**Re: Broadwater archaeological exemption notification**

School Infrastructure New South Wales (SINSW) on behalf of the Department of Education (DoE) proposes to make modifications to the Broadwater Public School, which includes the demolition of current school buildings, and construction of new buildings.

**Plate 2**      **The proposed site plan for Broadwater Public School Option 1.**

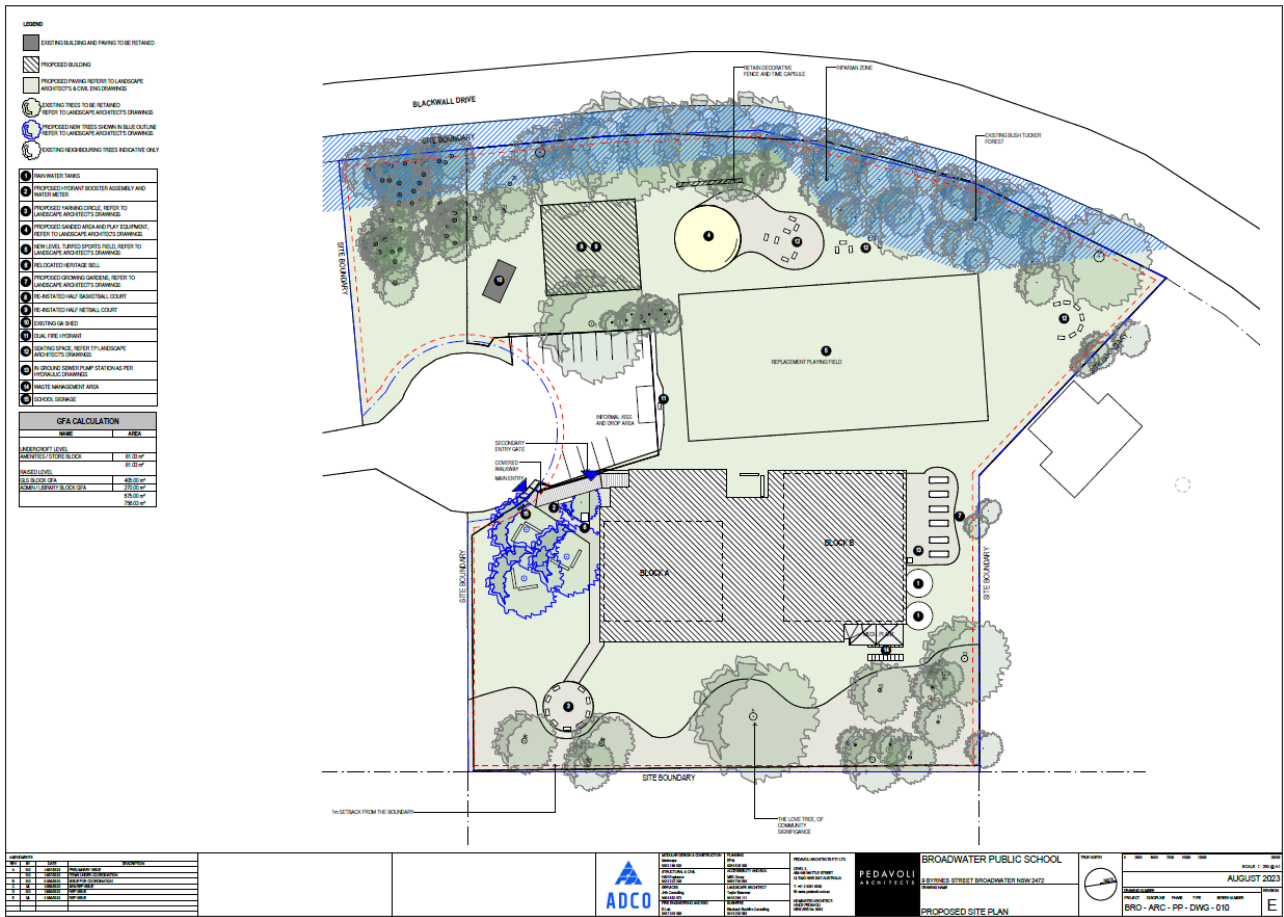
EMM Consulting Pty Limited (EMM) was engaged by SINSW to prepare baseline historical heritage assessments (hereafter baseline assessment) to contribute to the design of the recovery program. The baseline assessment identified two areas of archaeological potential (Plate 1). The south most area was identified as having the potential to retain archaeological resources associated with the former school building and former schoolteacher's residence. At the time of preparation of the baseline assessment, the master plan for new buildings proposed at Broadwater Primary School intersected with these areas of archaeological potential (Plate 2).

Plate 3 Revised site plan for Broadwater Public School

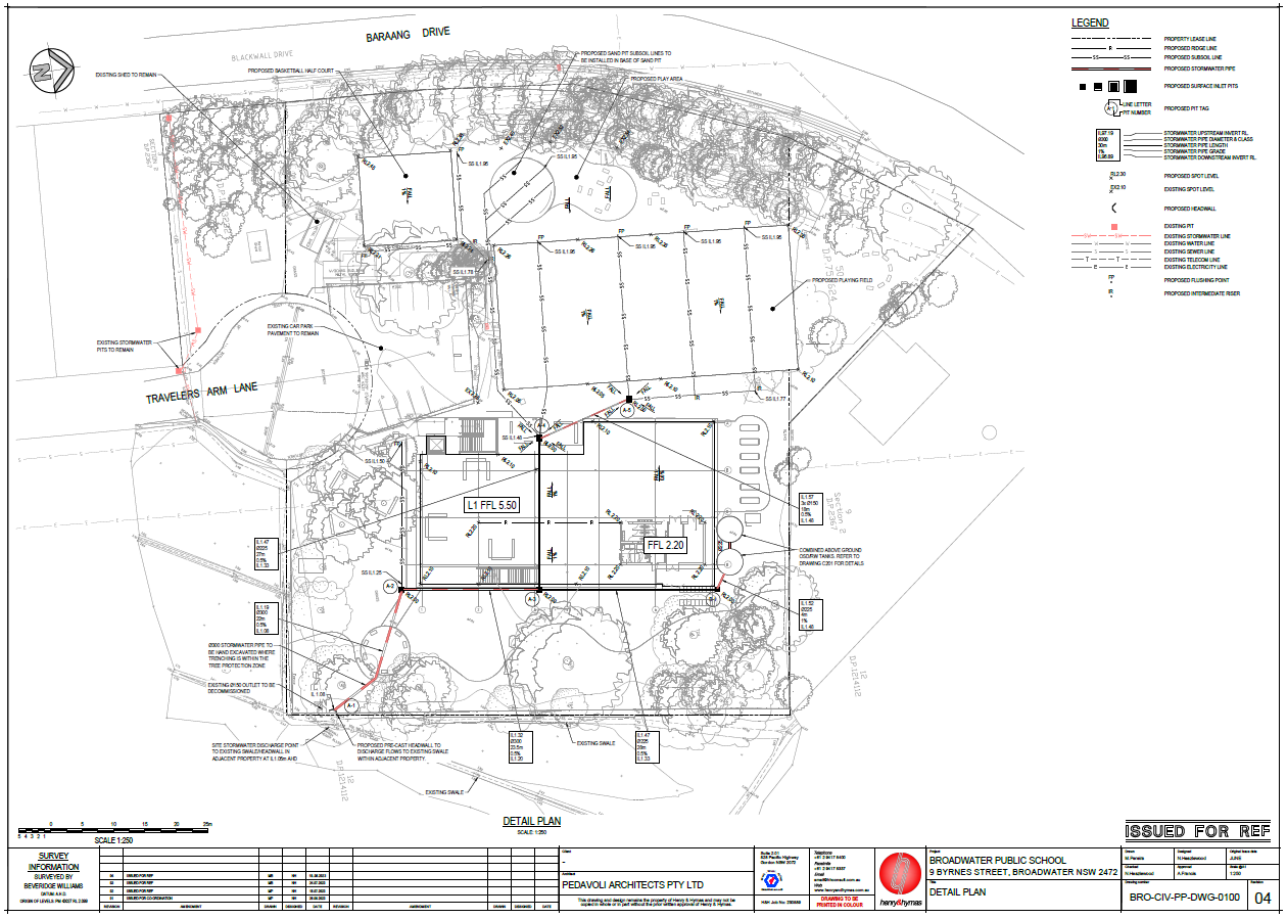
A subsequent redesign has relocated the proposed buildings outside the areas of archaeological potential (Plate 3). A service reticulation trench will run through the south most area of archaeological potential (Plate 4). The service reticulation trench follows the allotment boundary that existed between the former school building and former school teacher's residence. As such, there are no known or potential archaeological resources in the alignment of the service reticulation trench.

It is EMM's opinion that the redesign and construction methodology, as intimated to EMM, has removed the previously identified impact to areas of archaeological potential. Archaeological testing is therefore no longer warranted. EMM have provided the preceding advice on the basis that:
